UN Regulation No. 127 (Pedestrian safety)

Proposal for Supplement 3 to the 03 Series of Amendments and Supplement 2 to the 04 Series of Amendments to UN Regulation No. 127 (Pedestrian safety)

**Submitted by the experts from Germany, France, the Netherlands, and
the International Organization of Motor Vehicle Manufacturers^{*,**}**

"Figure 13
Upper Corner Definition with "Shortest Distance"

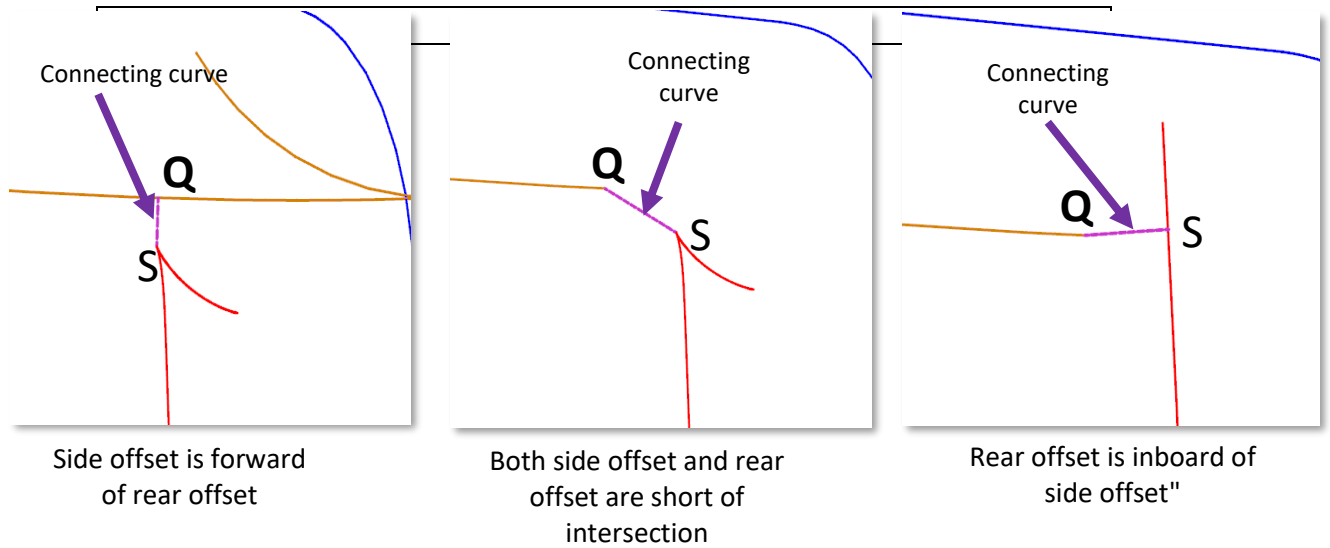
Paragraph 2.44., Figure 13, amend to read:

This proposal clarifies how to define the thirds of the windscreen test area, corrects the names of the upper corners as Q and Q' instead of R and R' in Figure 13, and update Figure 14.

"Figure 14
Lateral Limits of the Cowl Monitoring Area

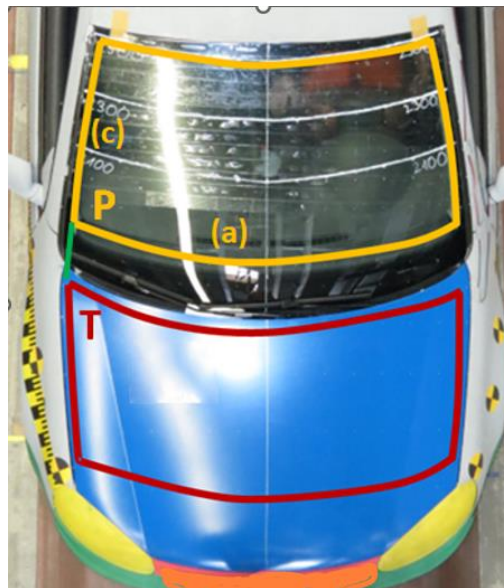
Paragraph 2.45., Figure 14, amend to read:

Figure 17
Thirds of the windscreen test area

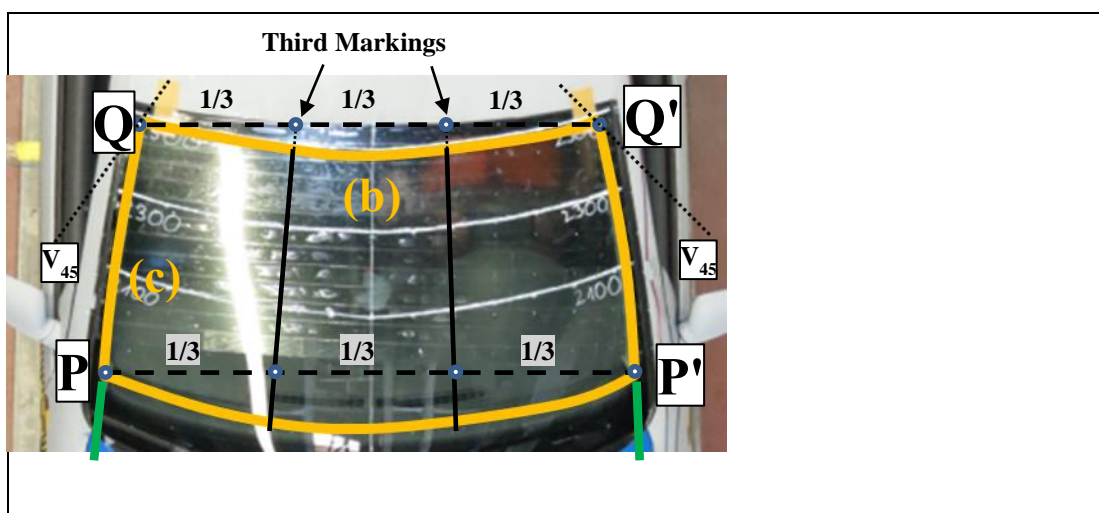
Paragraph 2.49., amend to read:

"2.49. **"One third of the windscreen test area"** means ~~the geometric trace of the area between the lateral side boundaries of the windscreen test area as defined in paragraph 2.44.(c), measured with a flexible tape following the outer contour of the windscreen on any transverse section, divided in three equal parts~~ **divided by the lines passing through the third markings of the lines from P to P' and from Q to Q' (the upper corner points of the windscreen test area), as shown in Figure 17. All lines are to be drawn and the three equal parts to be measured with a flexible tape following the outer contour of the windscreen. In case Q and Q' are coincident with P and P', Q and Q' are to be created on the side boundary lines as defined in paragraph 2.44. (c) rearward of P and P', respectively.**

If there is no unique "Q point" where the lines defined in paragraph 2.44. (b) and (c) intersect, then the "Q point" is defined by the first contact of a vertical plane V_{45} , intersecting the vertical longitudinal vehicle centre-plane at an angle of 45° , with the (b)-(c) transition of the windscreen test area boundary.

If there is no intersection between (b) and (c) and the open test area is closed by a connecting line, as illustrated in Figure 13, then the "Q point" is defined by the centre of this connecting line."
